Access Compliance Report

Public Rights-of-Way

Intersection ID: 54151	Main Street: SANDERS_FARM_LN	Cross Street: WALNUT_FOREST_DR	Location: SW
ADA ID: 7BBE28BFBDA3	Ramp Type: Perp	Initial Pass/Fail: Fail	Overall Compliance: No
			Severity Score: 13.75

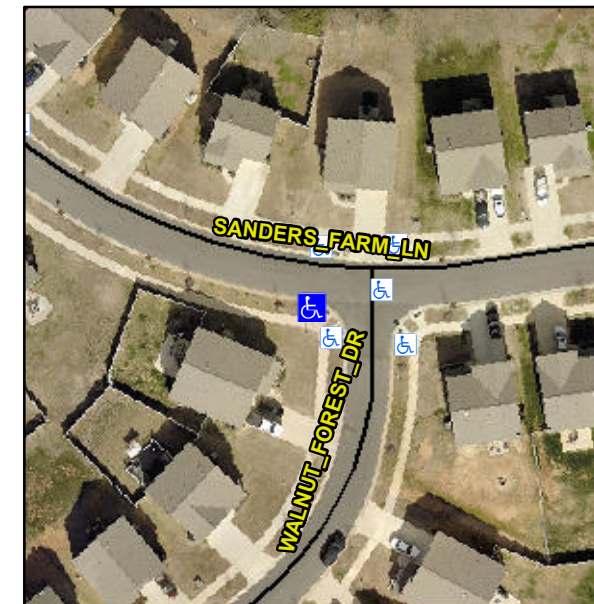
R304.2.2

Compliance	Description	Data	Compliance	Description	Data
N/A	Ramp Length (in)	93.5	No	Ramp Slope (%)	8.6
Yes	Ramp Width (in)	58.0	Yes	Ramp XSlope (%)	2.8
N/A	Flare Type LT	N/A	N/A	Flare Type RT	N/A
N/A	Flare Slope LT (%)	N/A	N/A	Flare Slope RT (%)	N/A
N/A	Flare Traversable LT?	N/A	N/A	Flare Traversable RT?	N/A
N/A	Landing Length (in)	N/A	N/A	DWS Provided?	N/A
N/A	Landing Width (in)	N/A	N/A	DWS Contrast?	N/A
N/A	Landing Slope (%)	N/A	N/A	DWS Length (in)	N/A
N/A	Landing X Slope (%)	N/A	N/A	DWS Full Width?	N/A
N/A	Landing Curb? (Y/N)	N/A	N/A	DWS Offset (in)	N/A
N/A	Shared Landing?	N/A			
N/A	Gutter Ponding?	N/A	N/A	Gutter Slope (%)	N/A
N/A	Gutter Lip Ht (in)	2.0	N/A	Gutter X Slope (%)	N/A
N/A	Painted X Walk1?	No	N/A	Painted X Walk2?	N/A
	X Walk 1 Direction	To N		X Walk 2 Direction	N/A
N/A	X Walk 1 Width (in)	N/A	N/A	X Walk 2 Width (in)	N/A
	X Walk 1 Slope (%)	2.1		X Walk 2 Slope (%)	N/A
	X Walk 1 X Slope (%)	3.3		X Walk 2 X Slope (%)	N/A

Remove & Replace Entire Ramp.
